Revision	Note	Date + init
1.3	Updated	2022-07-18 PCR

www.jvl.dk					JVL A/S Bregnerødvej 127 DK-3460 Birkerød Tel: +45 4582 4440 Email: jvl@jvl.dk			File name: MAB23x-05_V1.3 Part no. MAB23x-05		
	Sign	Date	Unit	mm	Tolerances			Description Brake 24V for NEMA23 ID6.35/OD6.35 M8 1.5Nm		
Drw	PCR	2022-07-22	Scale	1:1	Unless Specified					
App	PCR	2022-07-22	 	A4	Linear	0.5~6	±0.1			
ERP	-	-				6~30	±0.2			
						>30	±2%			
					Angles	±3°

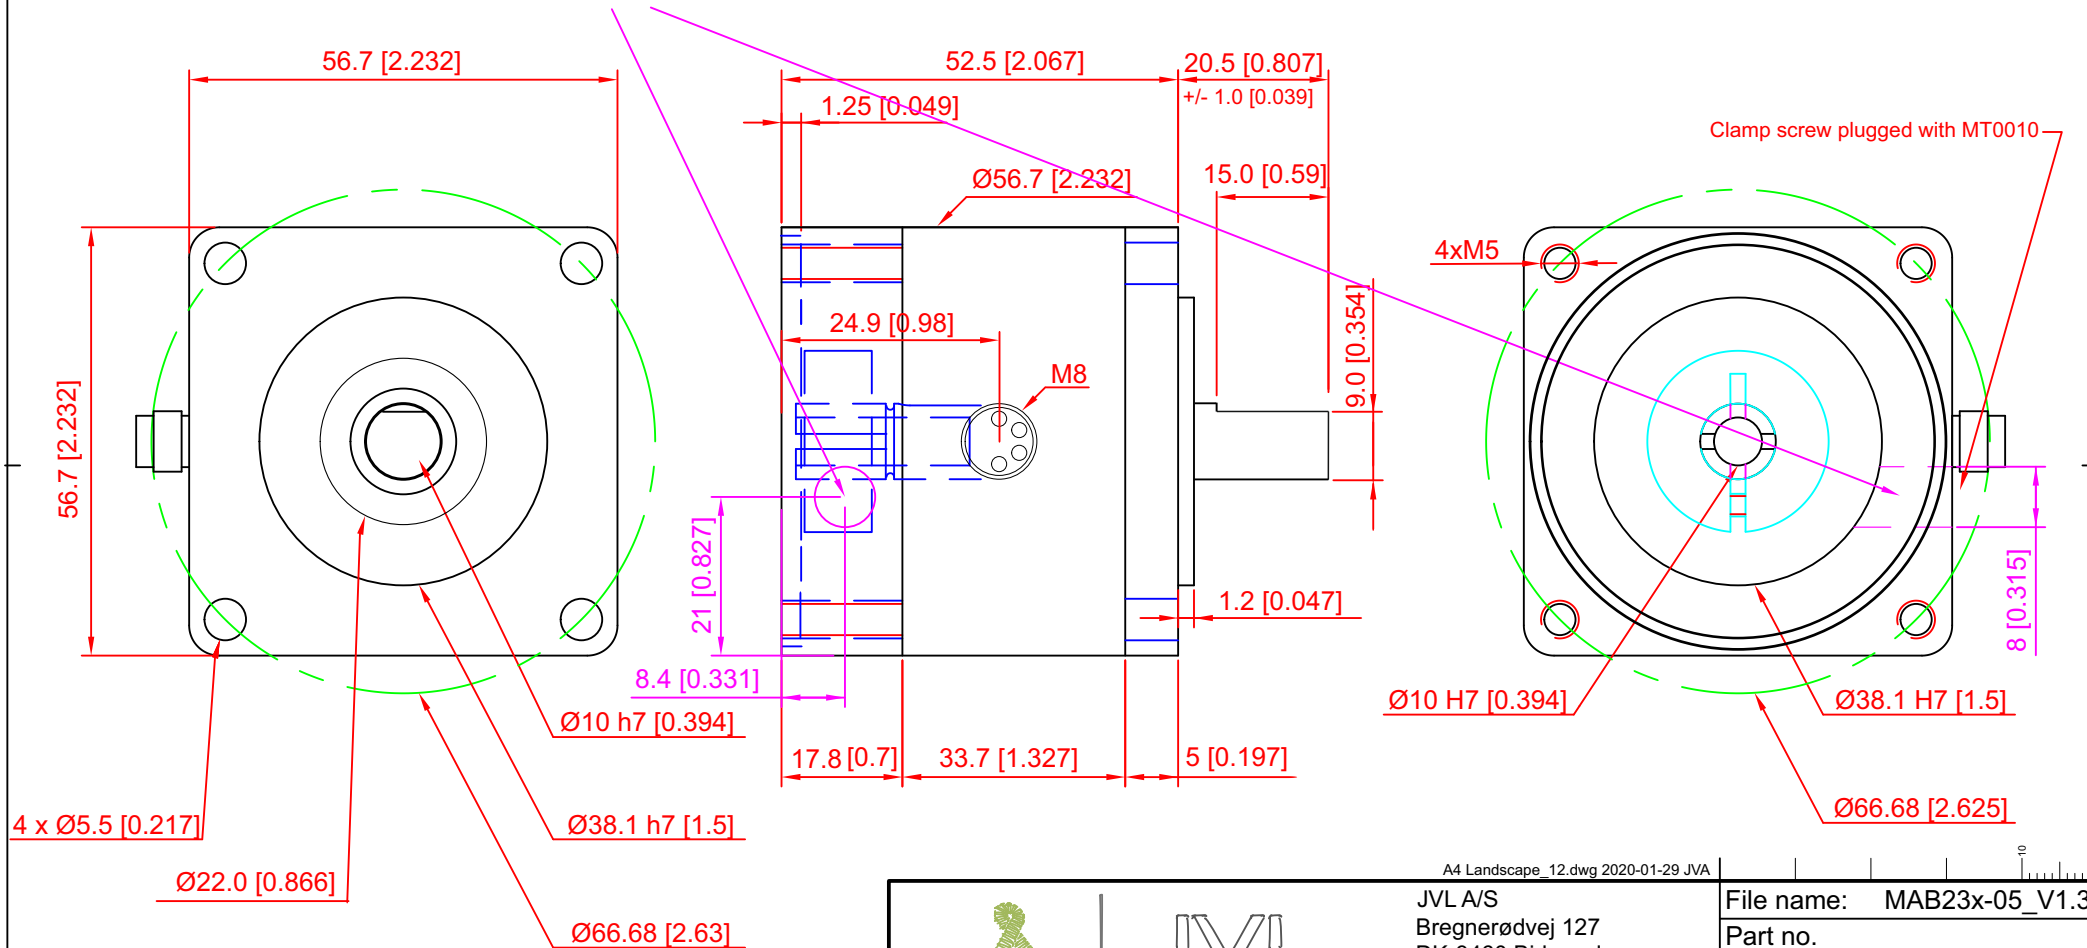
2020-01-29 JVA: Design Change Notification:
Ultimo 2020 the clamp screw hole will be on same side as connector and have diameter 8mm.
